Bid Bulletin #01

PROJECT: Shelton Public Schools
Additions & Alterations
Shelton, NE

DATE: March 21, 2014

**ADDITIONS & ALTERATIONS TO
SHELTON PUBLIC SCHOOLS
PROJECT NO. R-21113**

SHEET
PL103

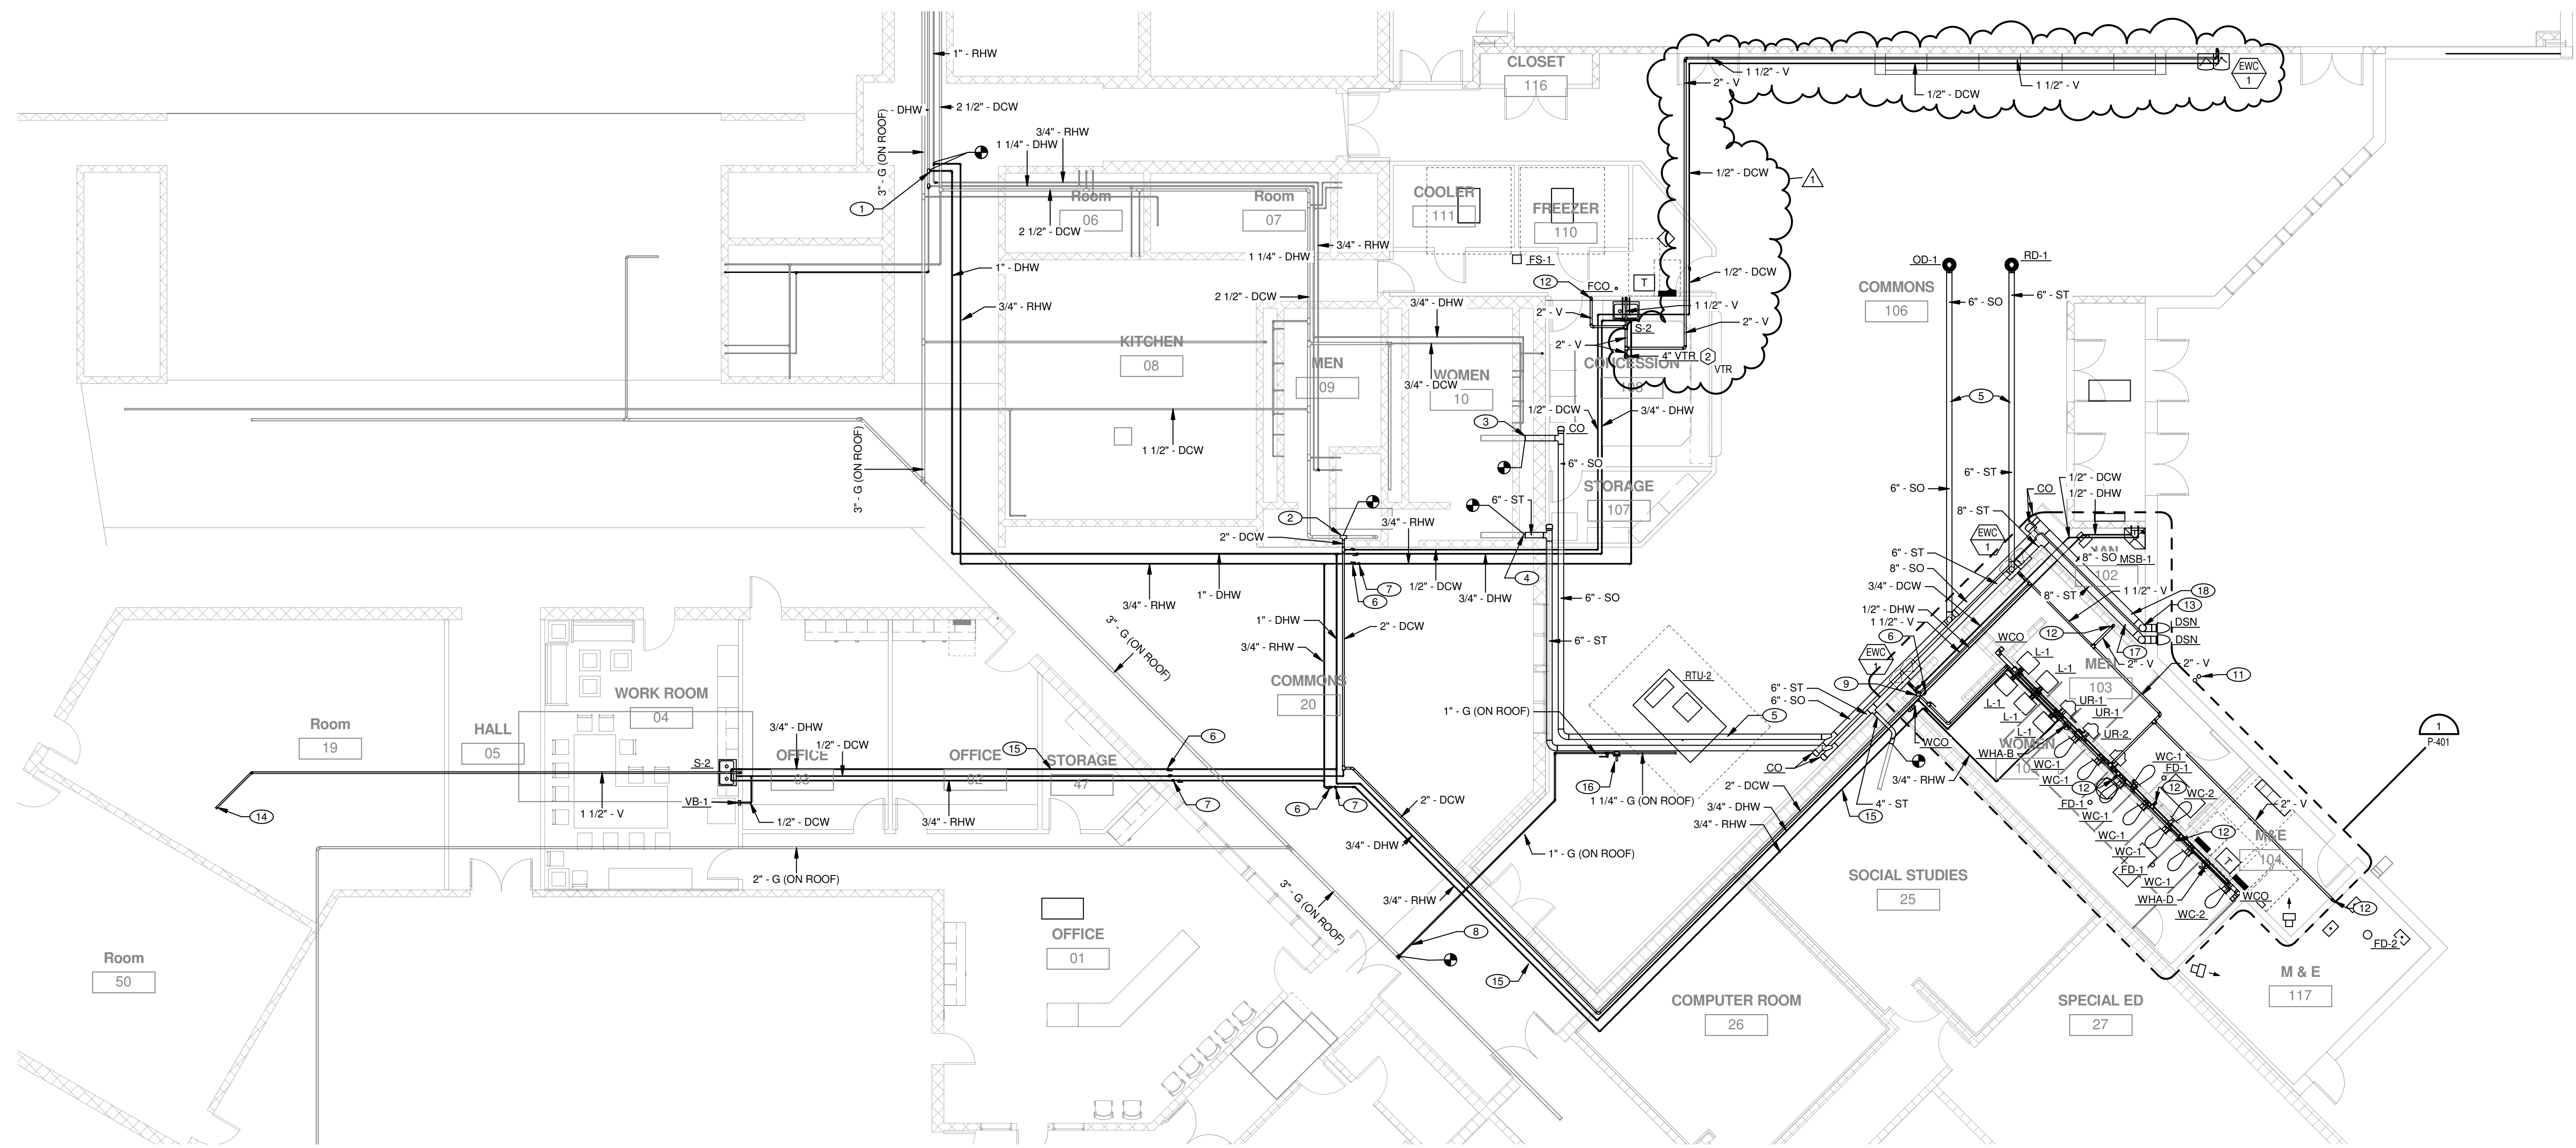
- M4: Drawing Sheet PL103, Level 1 Plumbing - North
- a. Modified domestic cold water and vent piping over to electric water cooler. Location of water cooler shifted West per Architectural Plans. See Reissued Sheet PL103 for revised piping. See Architectural Plans for new water cooler location.

- b. The eastern-most water closet WC-1 in Mens Room 103 is changed to UR-2 per the Architectural Plans. Related to that change, the UR-2 currently shown on the plans will instead be a UR-1. There are no pipe sizing changes related to this change. See Architectural Plans for new plumbing fixture configuration.

OVERALL SITE PLAN
SHELTON PUBLIC SCHOOLS
 SCALE: 1:40

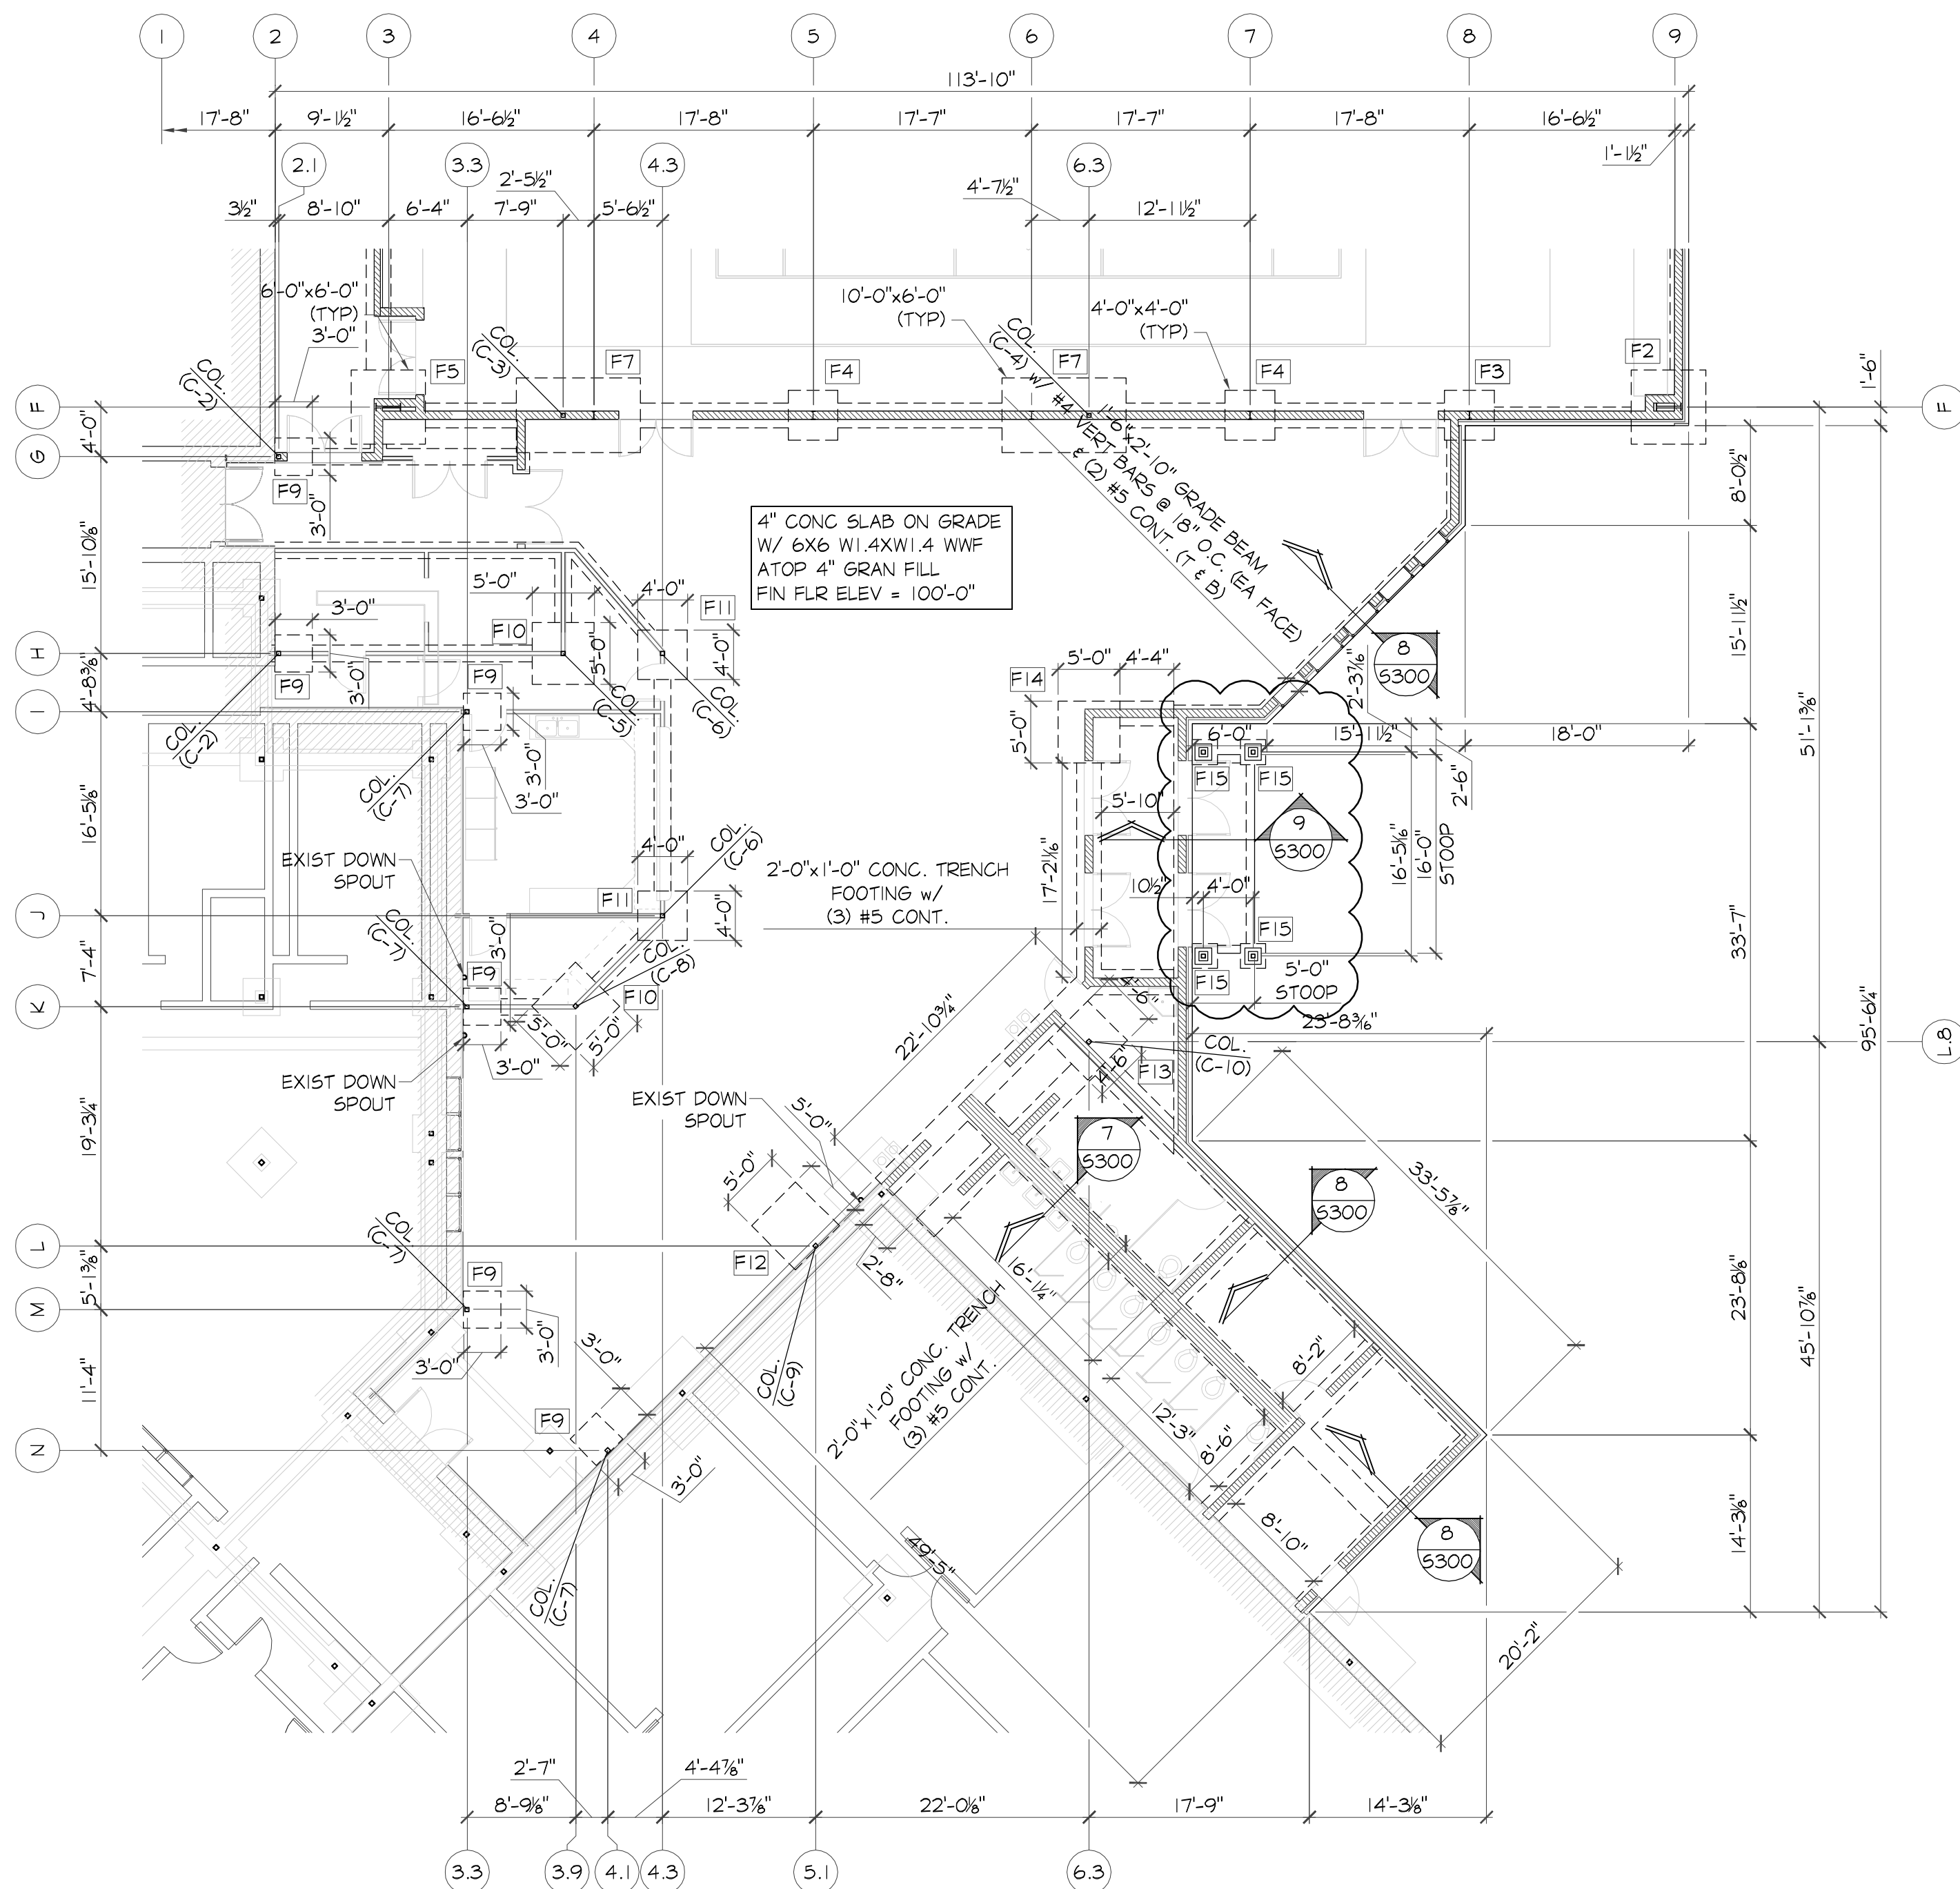
- a. Revisions to this sheet include revising the driveway and proposed parking lot north of the existing school. Also, two (2) proposed parking lot lights located at the south end of the west parking lot were not part of the electrical site plan and therefore shall be removed.

FOUNDATION PLAN - COMMONS AREA / BATHROOMS

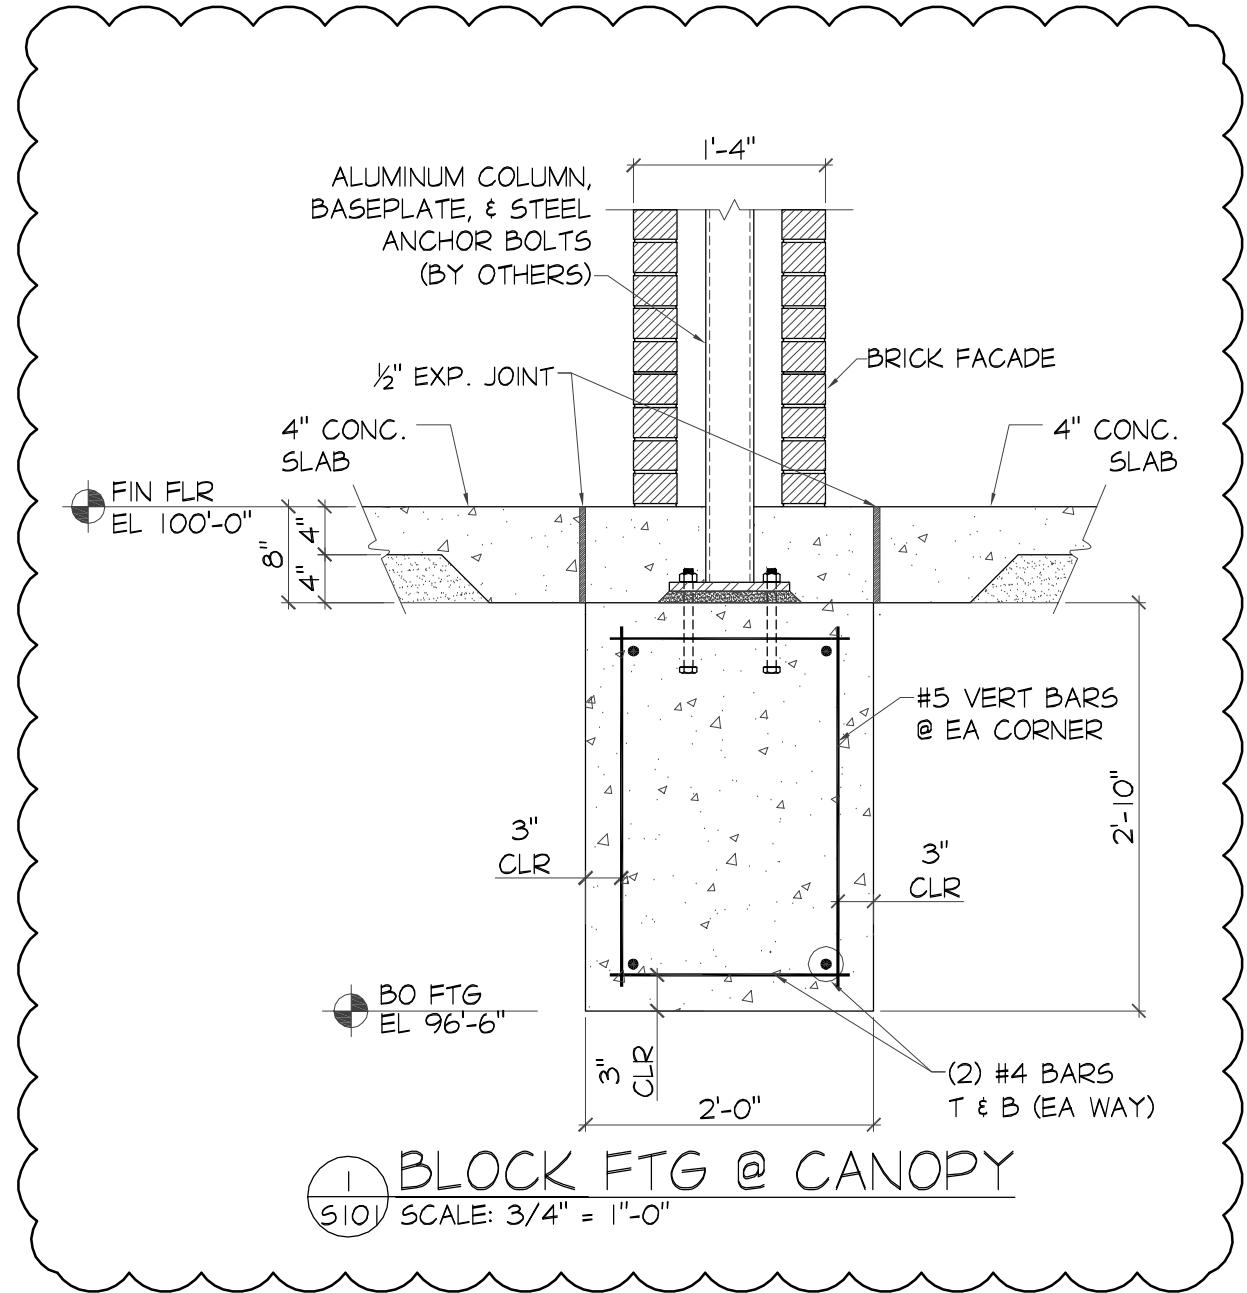
- a. Included are two (2) 2'-0" x 2'-0" x 2'-10" deep reinforced concrete footings for the proposed aluminum canopy to be installed in front of the west entrance to the Commons Area.
